MENDOCINO HISTORICAL REVIEW BOARD STAFF REPORT

JULY 1, 2019
MHRB_2016-0018

PROJECT DESCRIPTION: A Mendocino Historical Review Board Permit request to demolish, reconstruct, and/or construct the Ferro House, garage, tower, fencing, driveway and other structures. Note: Mendocino Town Plan Appendix 1 lists the site as a Category IIa Historic Resource.

STREET ADDRESS: 45270 Albion Street, Mendocino (APN: 119-217-06)

**HOUSE SOUTH ELEVATIONS -
EXISTING & PROPOSED**

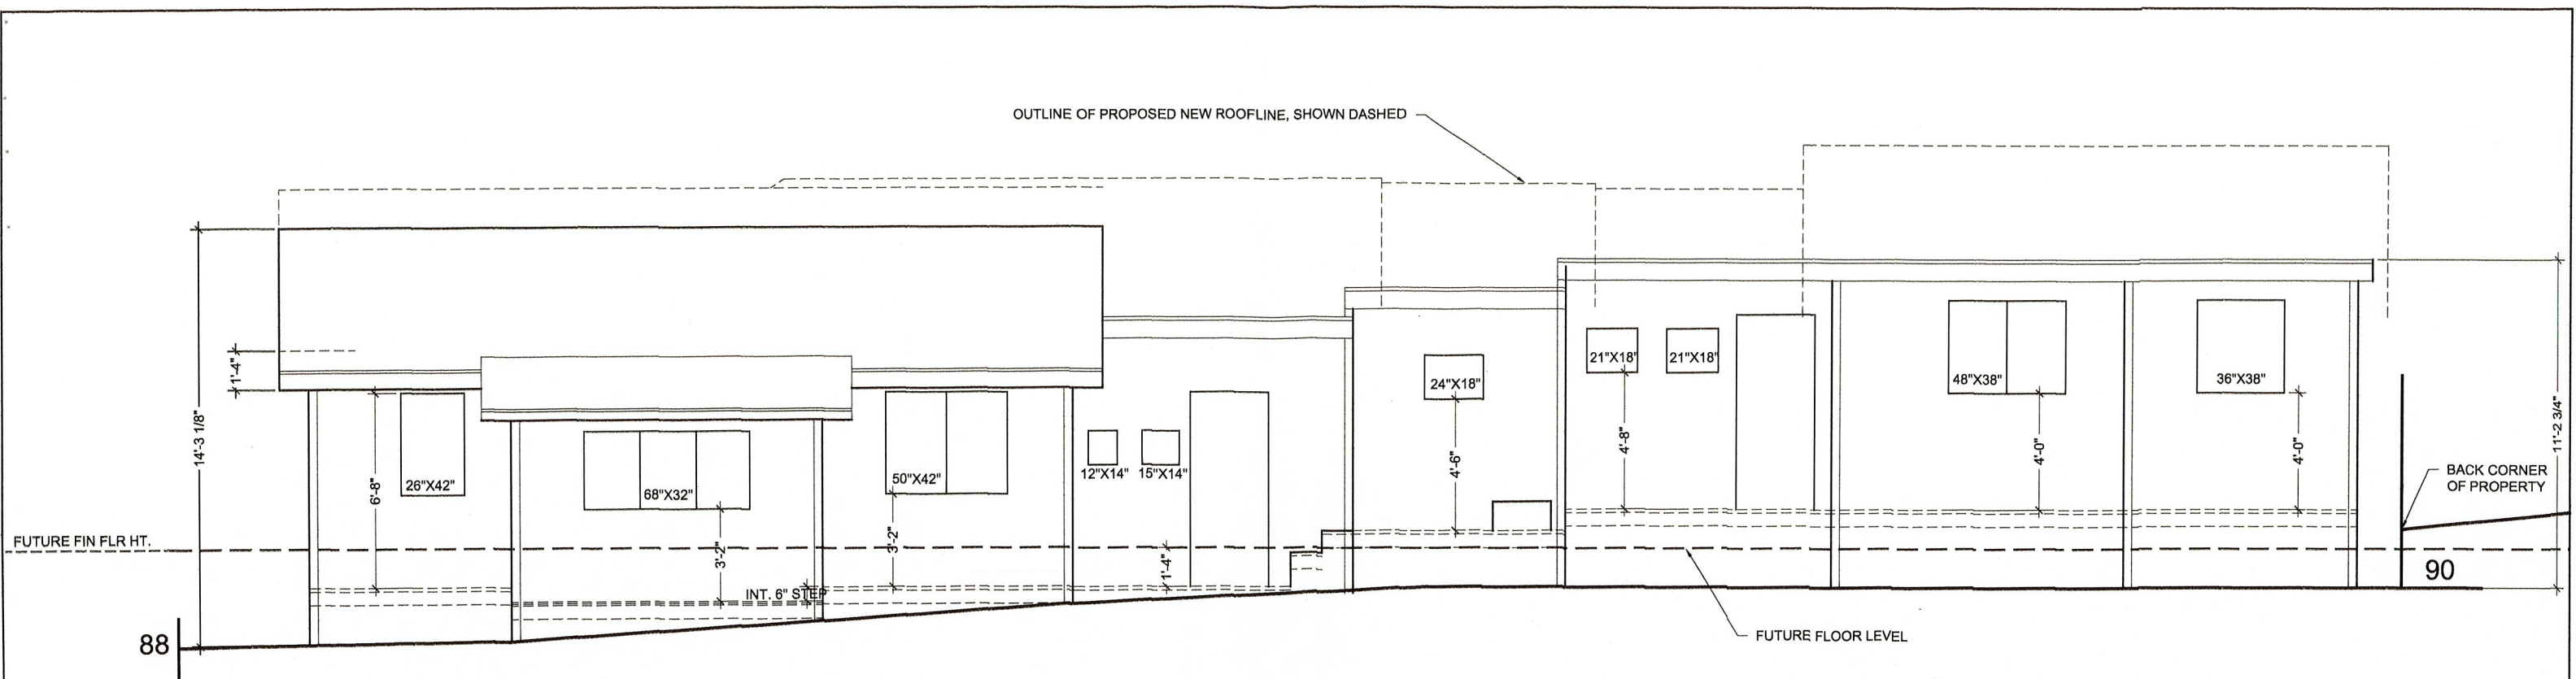
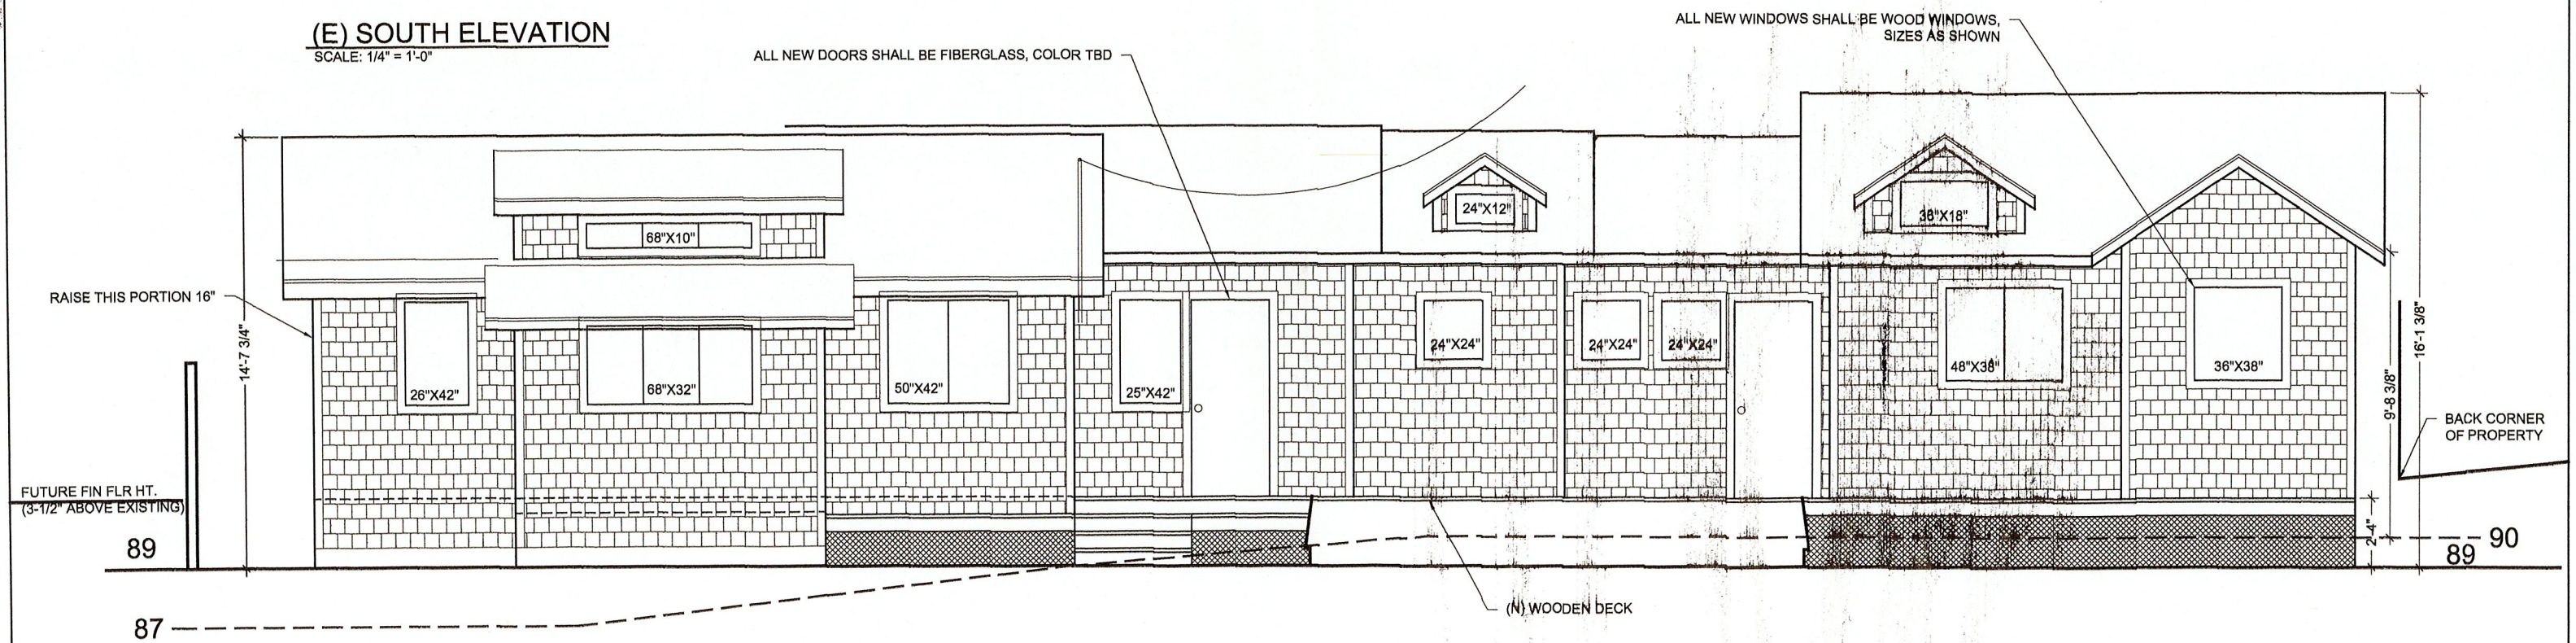
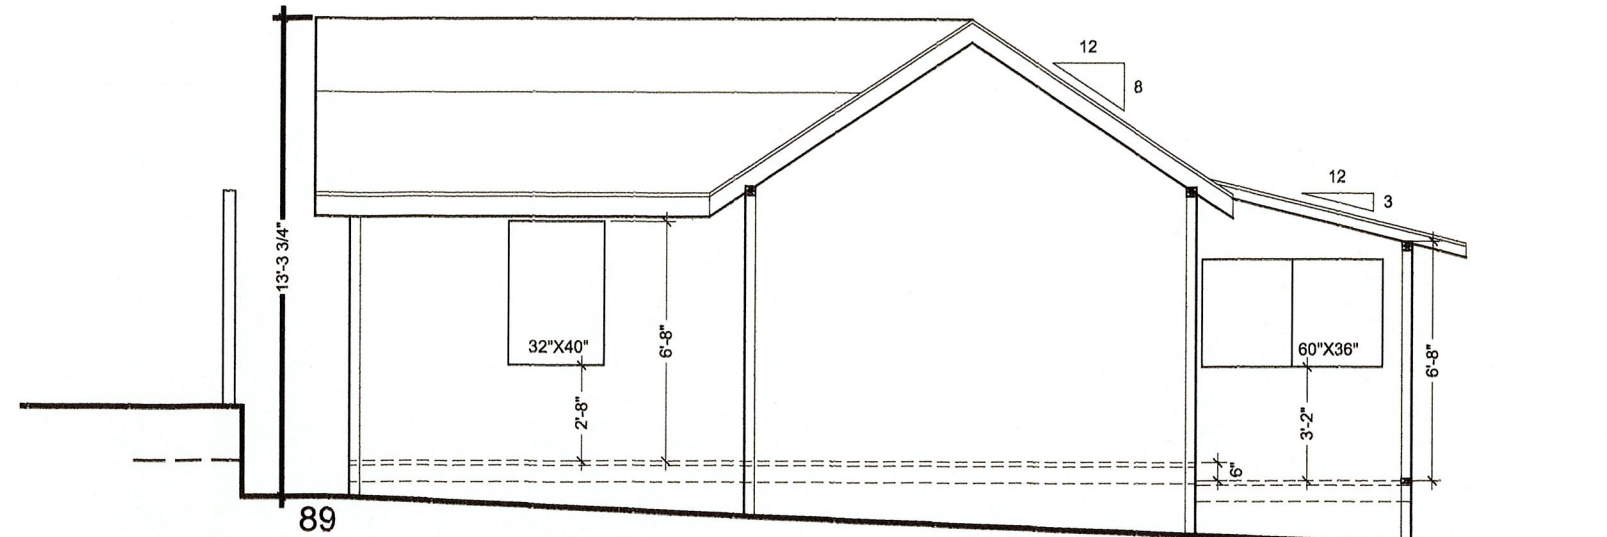
Proposed House Restoration and New Construction. The siding to the house (cabin, mudroom, additions) would be cedar shingles with oil finish to help preserve the material. Redwood trim would be painted forest green. The cabin, mudroom, and additions would be reconstructed in the existing foot print. The rooflines would be reconstructed with the same 8:12 pitch as shown on the as-built plans, except the circa 1980 addition with flat roofs would be rebuilt with a 8:12 pitched gabled roof running east west. Asphalt shingles would be used throughout. Existing windows would be replaced with wood-frame windows having mostly the same size, style, and shape. Windows would be placed within the proposed dormers. Doors would be replaced with painted fiberglass doors. See Sheet No.'s A2 through A5 for existing and proposed elevations of the house.

10. To the satisfaction of the Director of Planning and Building Services, exterior house building plans shall provide sufficient detail for the successful reconstruction of the cabin, mudroom, and additions with an 8:12 gabled roofline.

**TOWER NORTH & EAST ELEVATIONS -
EXISTING & PROPOSED**

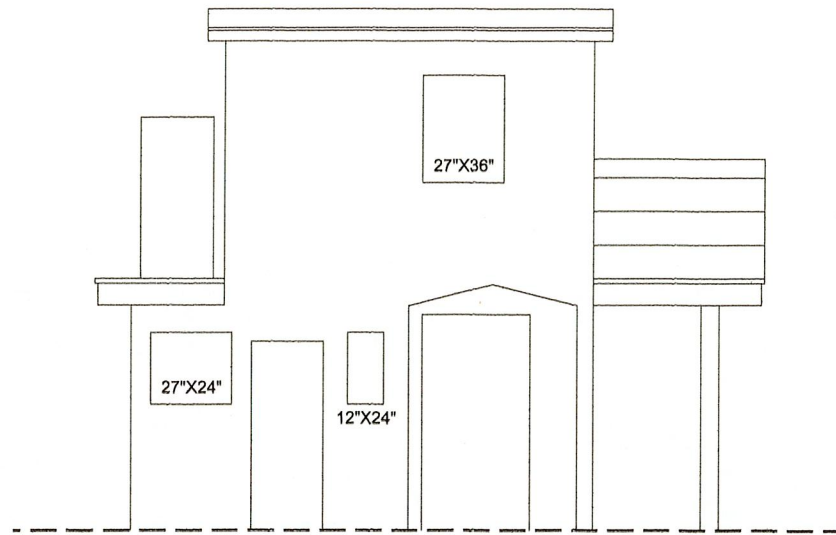
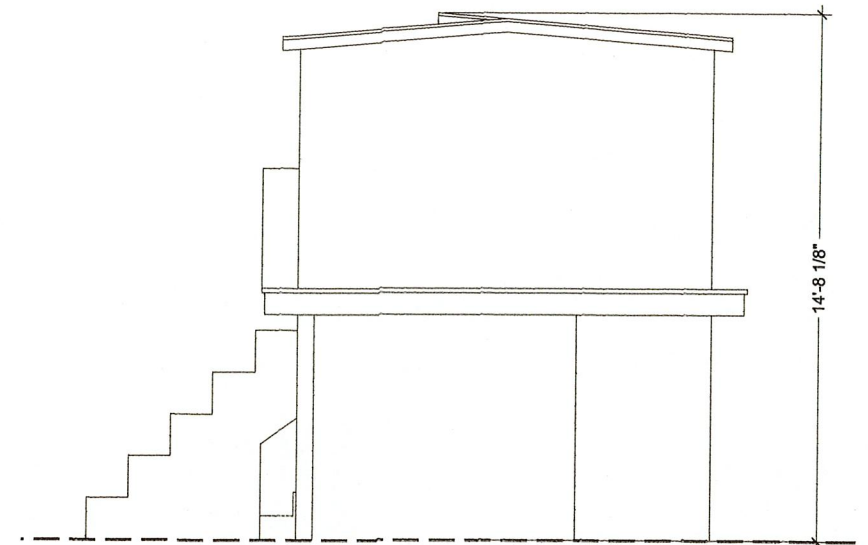
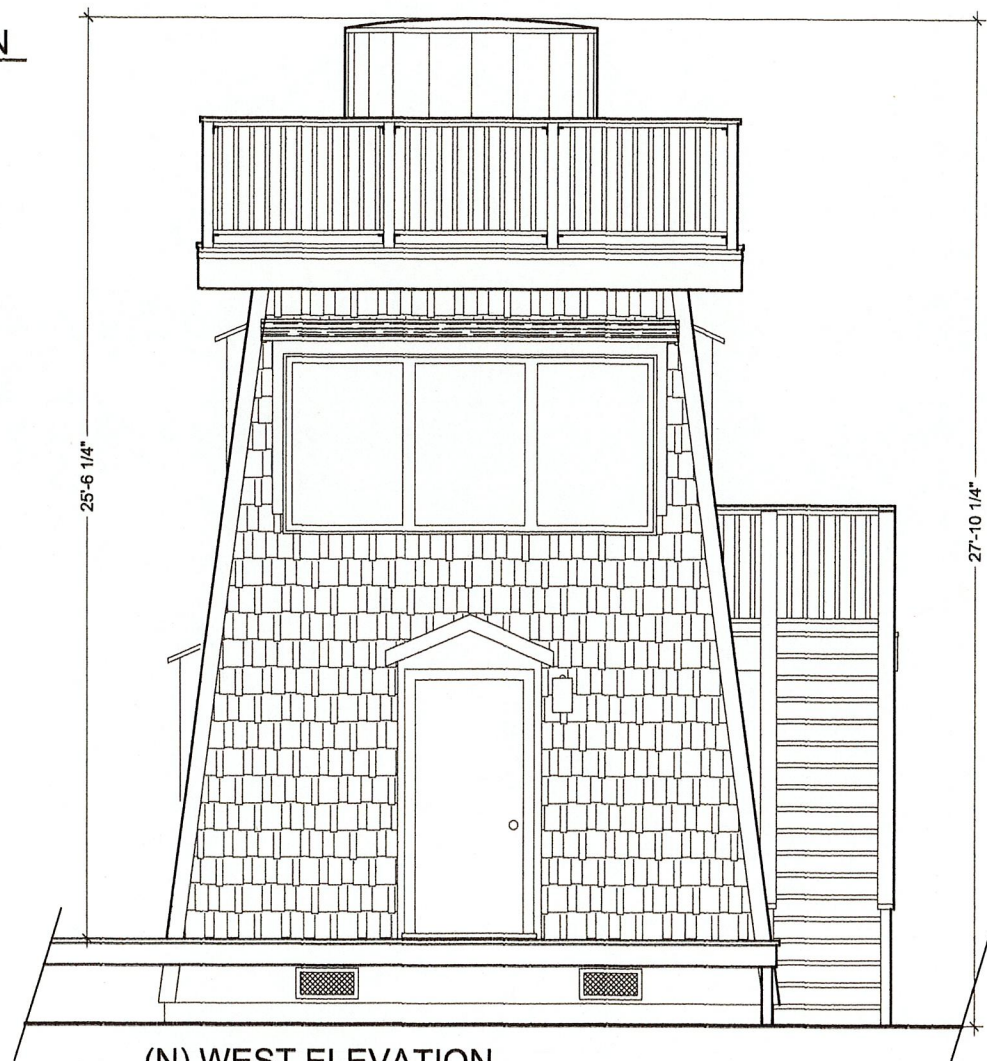
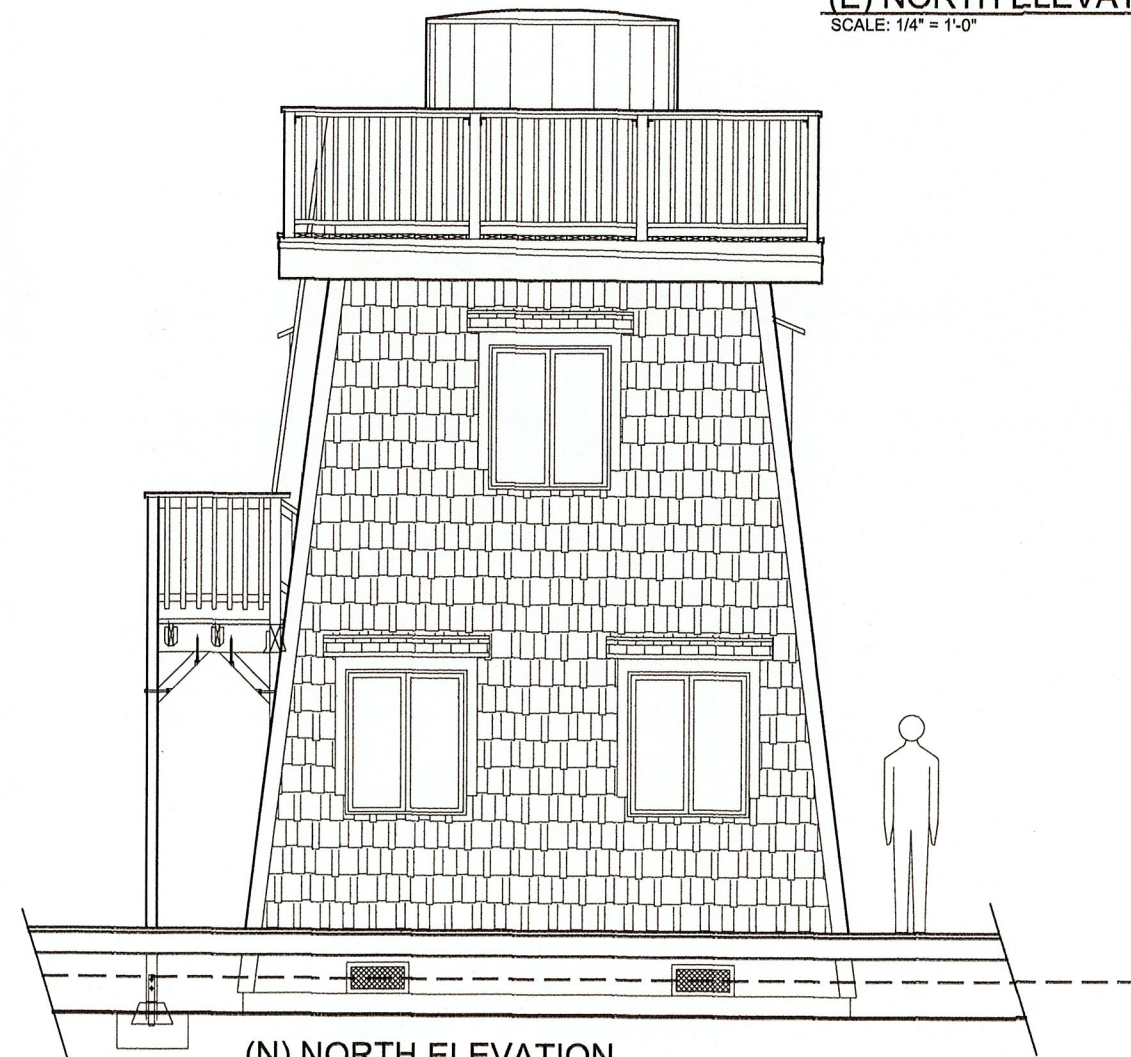
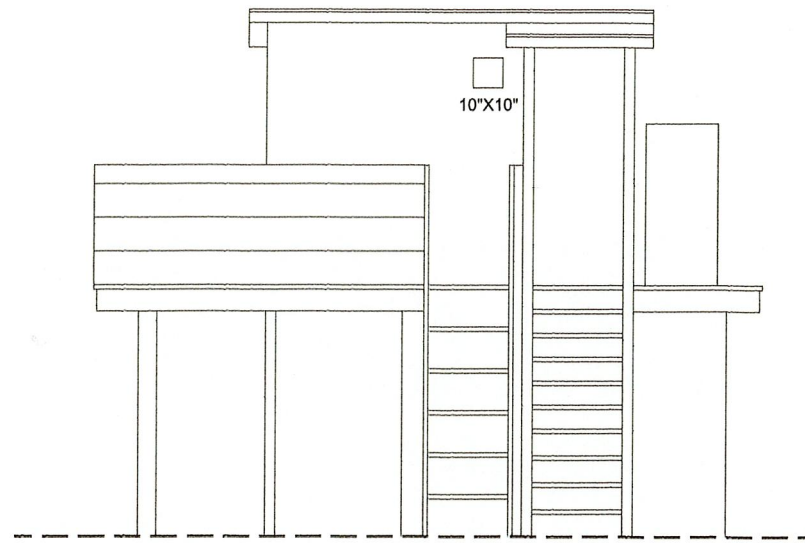
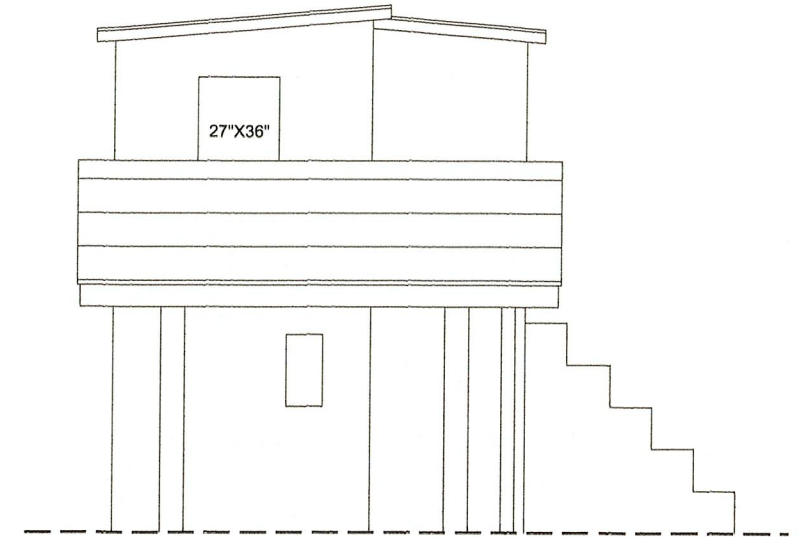
Existing Tower. The circa 1900 water tower is 14 feet in height and irregularly shaped (See Sheet No.'s A6 and A7 Tower Elevations). It has a footprint of approximately 200 square feet and has three entrances, two on the primary level, and one on the second level, with both interior and exterior stair cases to the second level. The overall condition of the tower is poor (CHRC 2016).

Proposed Tower. The applicant proposes to demolish the existing tower and to construct a new tower rebuilt in the same location but with a larger footprint (See Site Plan and illustrative elevation drawing).

As an accessory structure, the proposed 28 foot tall tower footprint would be 290 square feet. The siding on the tower would be cedar and the trim would be painted forest green. The tower would have an exterior door on each level with an external staircase projecting from the building footprint. A new 2,800-gallon water storage tank would be located atop the tower. The proposed water storage tank exterior would be lined with redwood slats and enclosed with metal bands. The proposed tower would be 28 feet in height above grade including the additional height of the water storage tank.
